# City of Coconut Creek

Subject: The Promenade at Coconut Creek  
Modification to Site Plan

Re: Promenade at Coconut Creek- Building D Signage Clarification

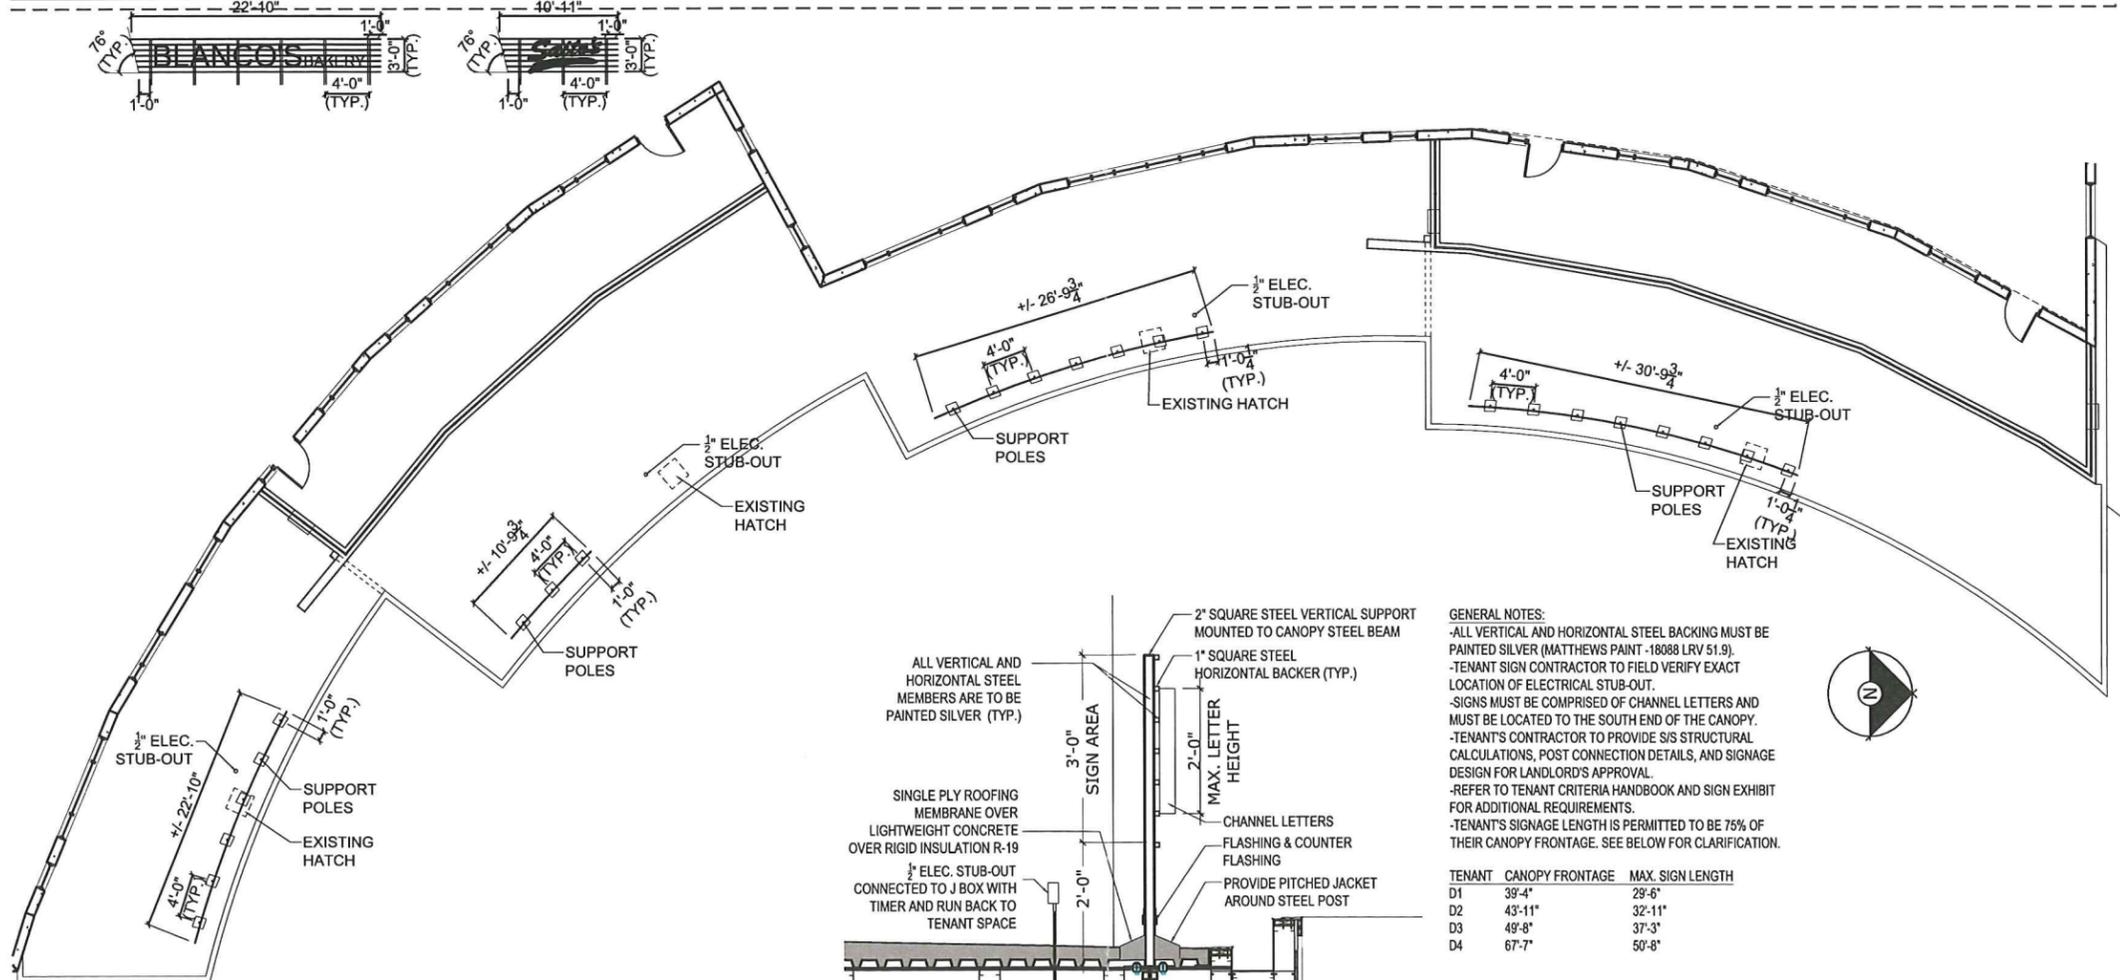
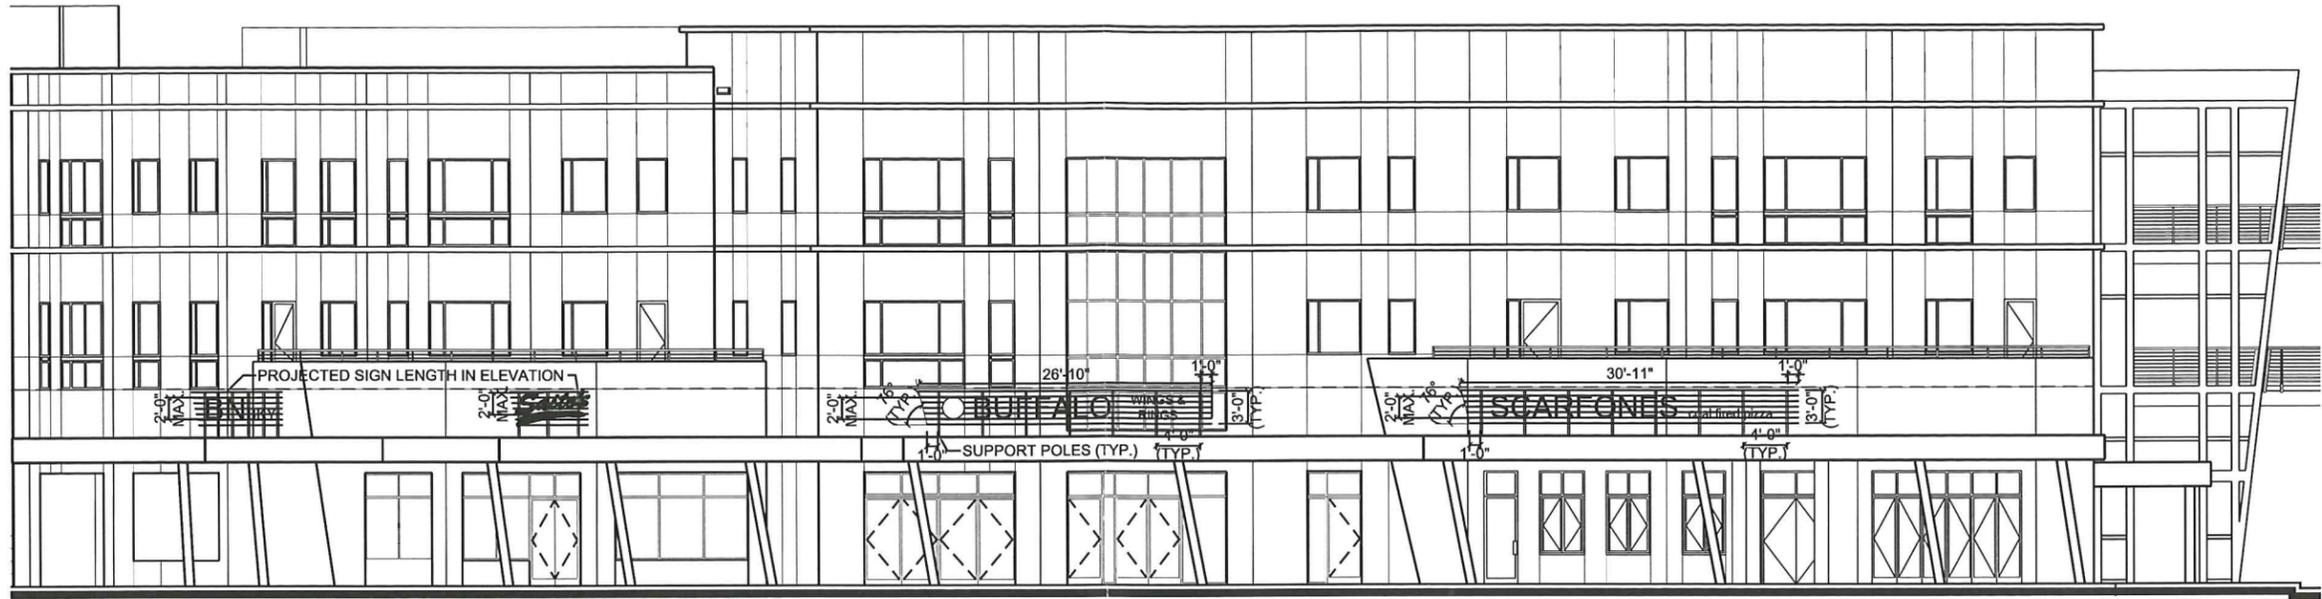
The applicant is requesting to modify the signage for Building D based on the architecture of the building, more specifically signage for the tenants located on the first floor. Signs for the first floor tenants are permitted on top of the canopy, which projects from the building façade thereby creating unique criteria for the signs. City staff along with the developer created specific sign criteria to ensure permitting would be efficient.

1. Signs shall be located toward the south side of each tenant's canopy, unless tenant obtains written approval from Landlord to adjust.
2. Maximum length shall not exceed 75% of the canopy frontage for tenant area thereby establishing a maximum length consistent with code.
3. Individual Channel letters shall be required.
4. Font style, logo and colors shall be per tenant image and shall be approved by landlord.
5. Maximum letter size shall be 24" per tenant signage standards established for the center.
6. An additional sign for corner tenants (D1 & D4) will be considered by Landlord so long as the sign is not larger than 50% of the front canopy sign and is attached to the main building façade (not a canopy).
7. These requirements are intended solely for the first floor tenants of the D Building.
